Providence City
Administrative Land Use Authority (ALUA)

Agenda – July 29, 2020 – 2:30 PM

PROVIDENCE CITY
Land Use Authority – Staff Report
Meeting Date: July 29, 2020

Request: Applicant is requesting approval of a conditional use and zoning approval for a new home located at 680 E. 525 N. Providence, UT.

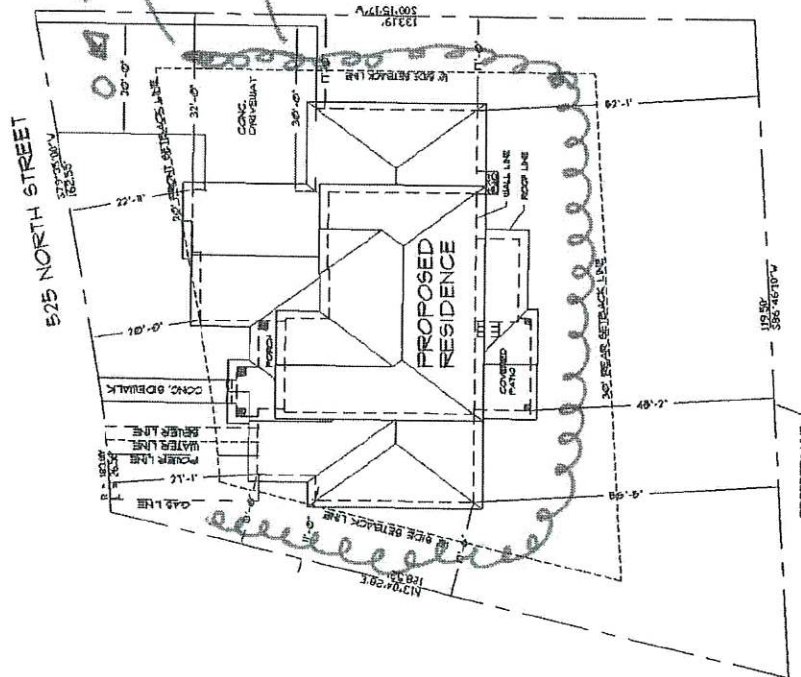
1. The applicant will continue to meet all relevant federal, state, county, and Providence City rules, laws, codes, and ordinances.
2. The applicant will mitigate Landslide Area by: See mitigation statement emailed dated July 27, 2020, and drawing on site plan.

Sorry, the earth berm is only retention mitigation during the construction process. Long term retention mitigation is provided by engineered home itself as well as finished grade and landscaping
